Access Compliance Report

Public Rights-of-Way

(Pedestrian Signals)

Intersection ID: N/A	Main Street:	Cross Street: N/A	Location: N/A
ADA ID: D465ED58A356	Signal Type: Two Push Buttons-Non APS	Overall Compliance: No	Severity Score: BTN 1:N/A BTN 2: N/A No BTN: N/A
Codes/Mitigation Info/Possible Solution		Field Measurements/Component Compliance

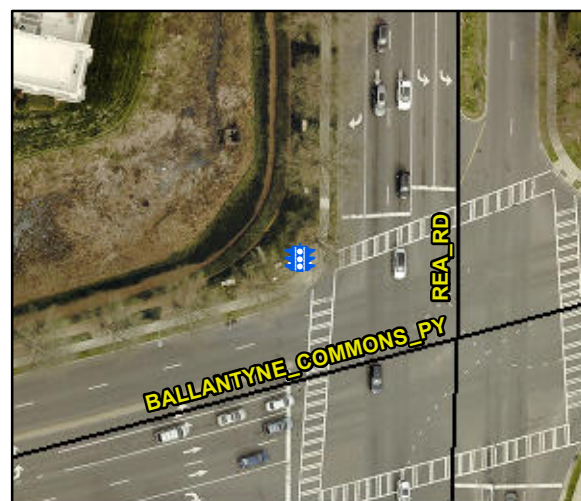
Possible Solutions: Replace Signal Push Button With APS Button on New Post. Remove & Relocate Sign.

PROW/ADA: R209.1, TMUTCD 4e.08, R404.2, R406.2
